COUNCIL ACTION FORM

**SUBJECT: REVISED MAJOR SITE DEVELOPMENT PLAN/PRELIMINARY PLAT
FOR SOMERSET SUBDIVISION**

SOMERSET SUBDIVISION
 PRELIMINARY PLAT/MAJOR SITE PLAN
 '06
 118

Proposed Somerset Plan

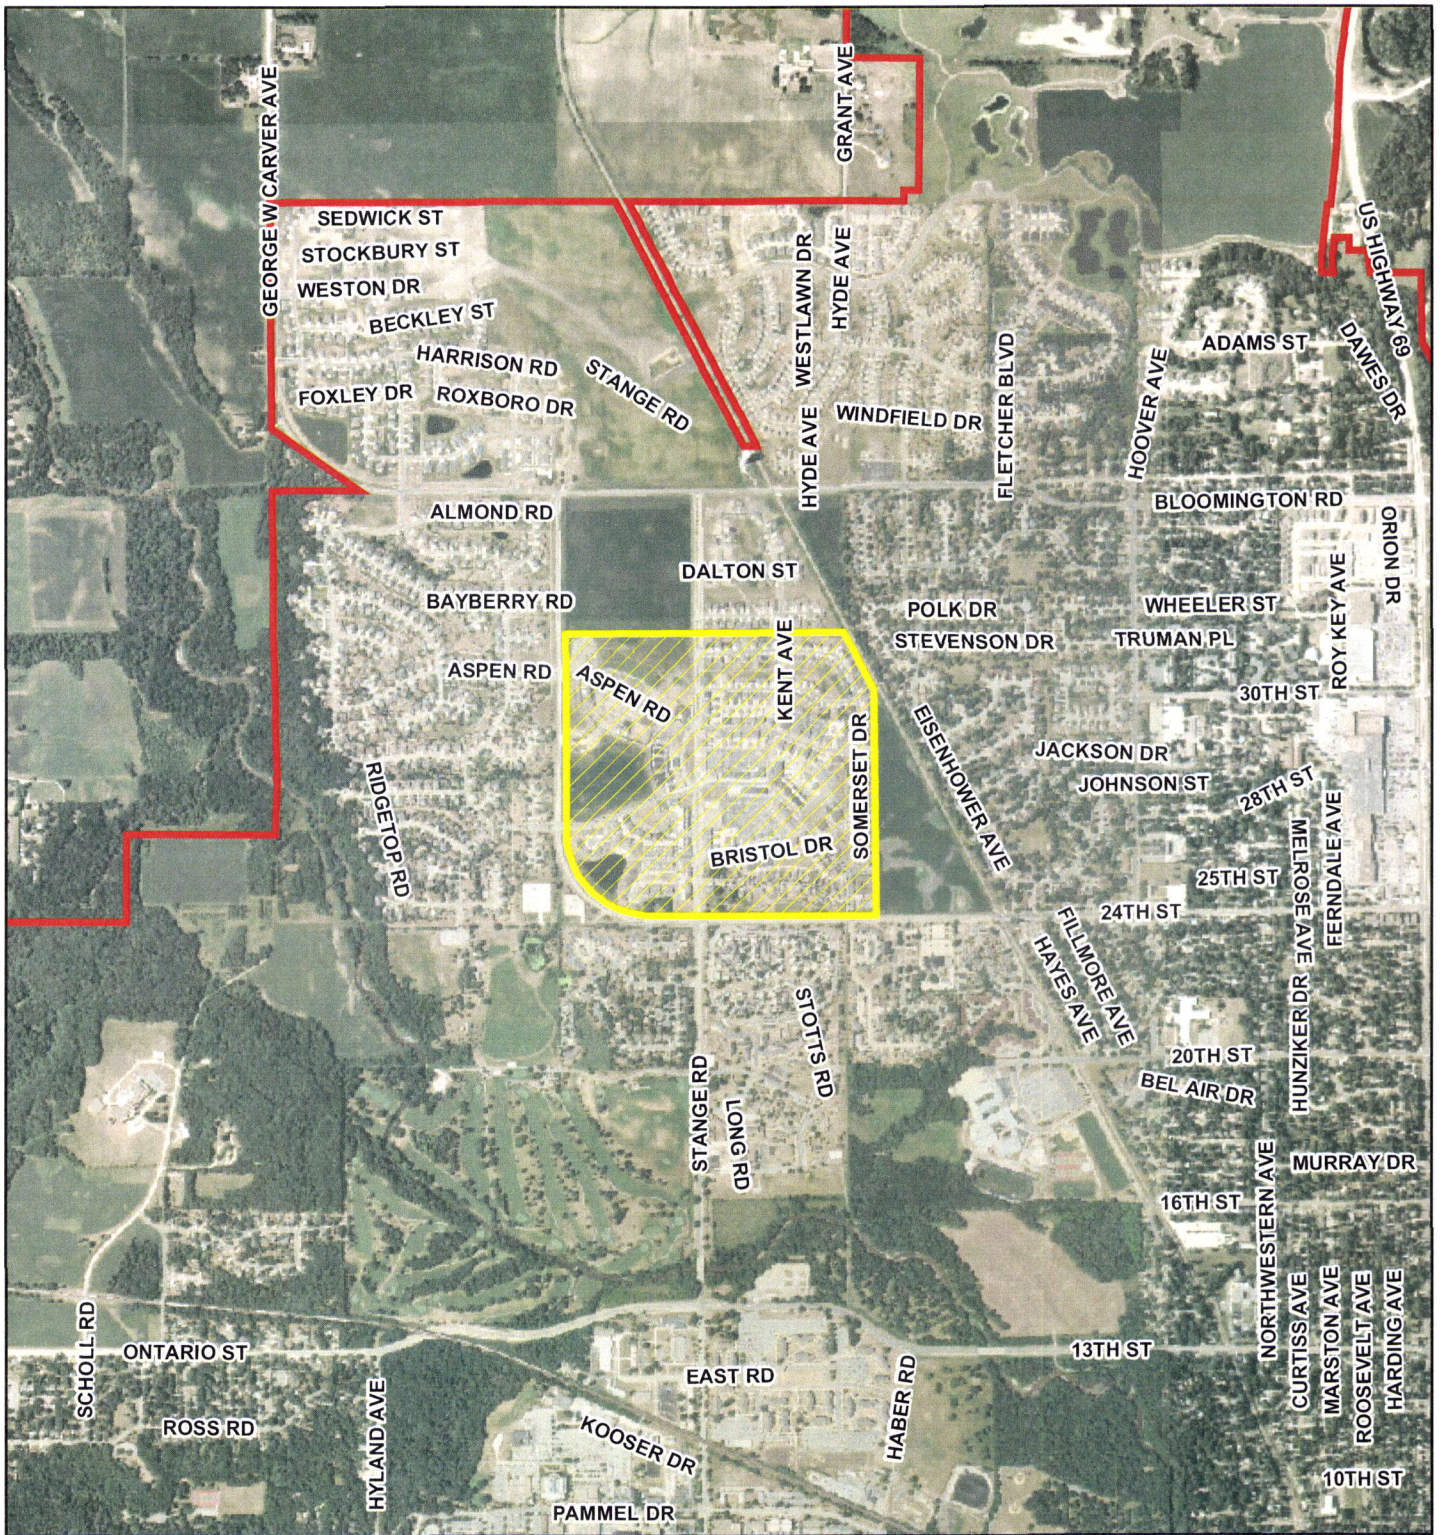
1. Change the type of housing planned for the lots along the south side of Bristol Drive, between the existing brick attached single-family dwellings (Row Houses) and the alley west of Kent Avenue from Row Houses to detached single-family dwellings (Village Houses). See **"#1 and #2" on the attached graphics of the "Approved Somerset Plan" and the "Proposed Somerset Plan."**

2. Reduce the number of lots for the area of Somerset, described in #1 above, from 12 to 5. See **"#1 and #2" on the attached graphics.**
3. Change the dimensions of lots proposed in Phase 22 of Somerset Subdivision. See **"#3" on the attached graphics.**

4. Add a van-accessible parking space in the parking lot adjacent to the building at 2707 Stange Road. See **"#4" on the attached graphics.**
5. Change Lots 21, 22, 29 and 39 in Somerset Subdivision Seventh Addition between Bradford Drive and Eaton Avenue from lots planned for Townhomes to lots that will be open space landscaped lots. See **"#5" on the attached graphics.**

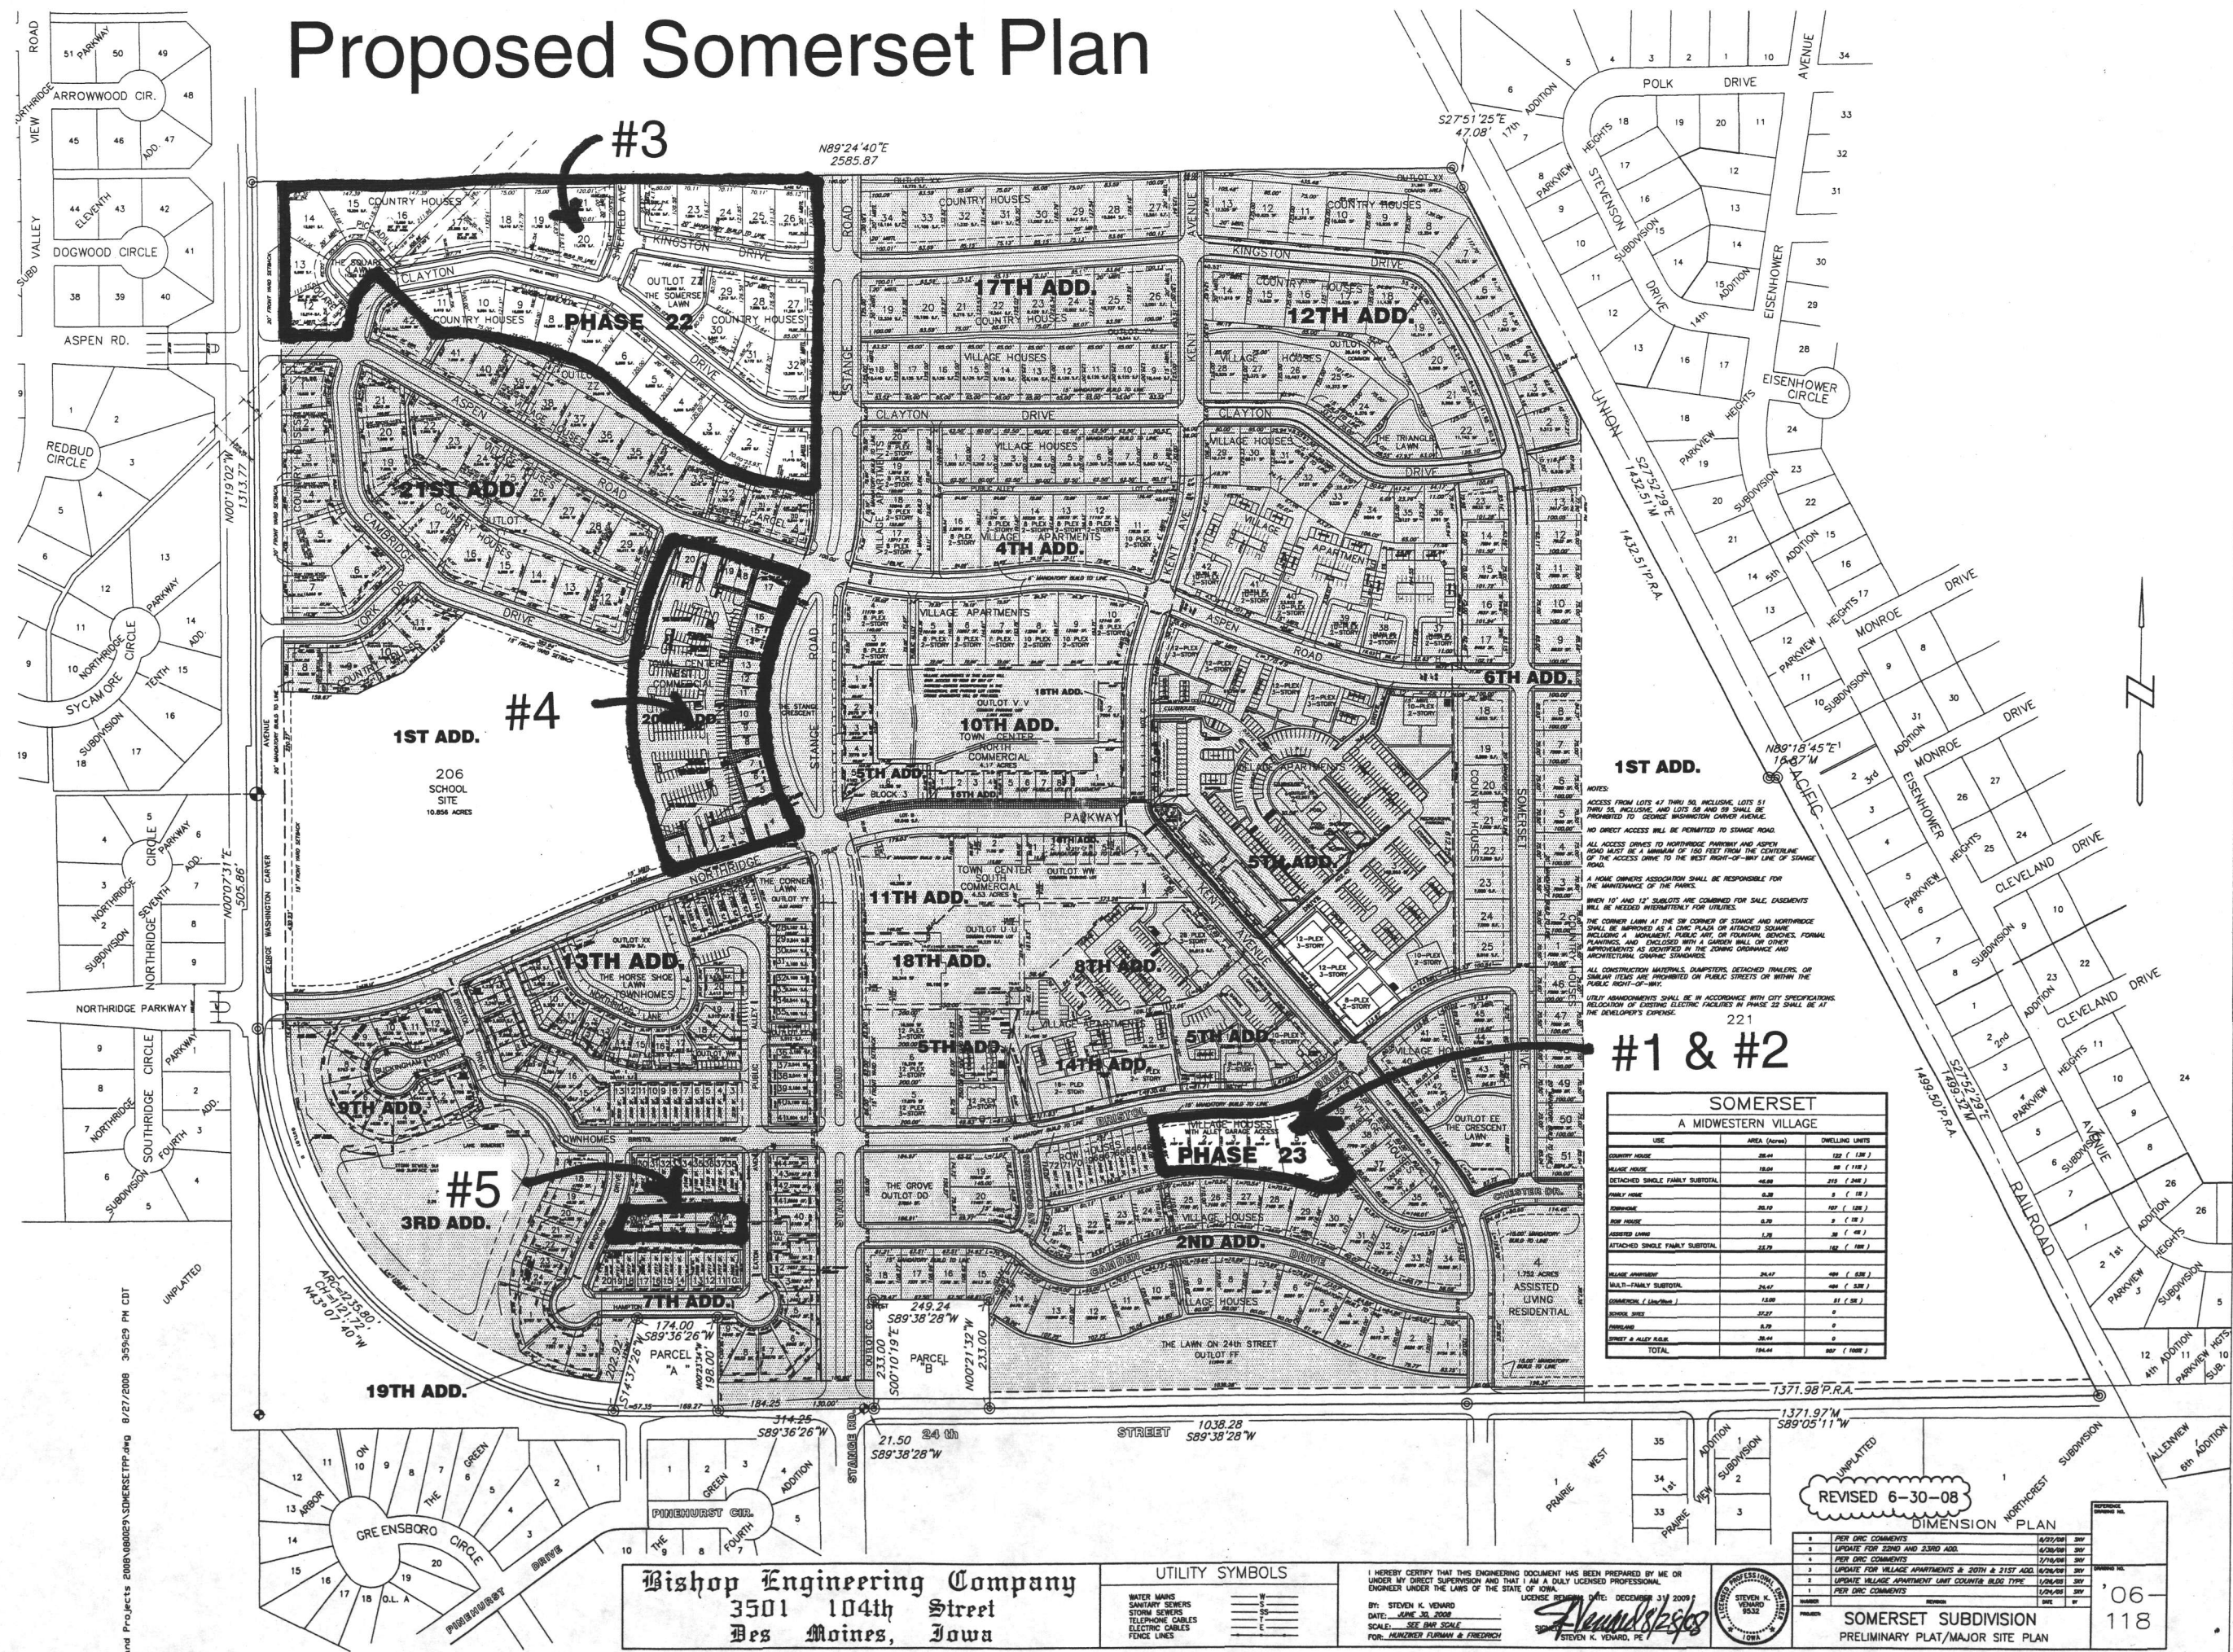
The response to the question of keeping the Row house planning or amend the planning for the construction of Village Houses was unanimous. Seven Association Board Members agree that the building of Village Houses in place of the Row house design would be acceptable, however, feel very strong about the need to address the snow removal problems which have become very apparent. The problem with small and large vehicle traffic through the alley, damage that has and continues to occur as vehicles leave the hard surface areas, and the issue of a dedicated place to locate plowed snow.

The alley problems are an issue that we feel the City of Ames and the Developers would want to address no matter which housing design is the final decision. Actual use of the alley has indicated a pattern of use by small and large vehicles. Snow removal becomes a significant problem which we have easily dealt with by using a small portion of the far east lot as a safe deposit point for the pushed snow.
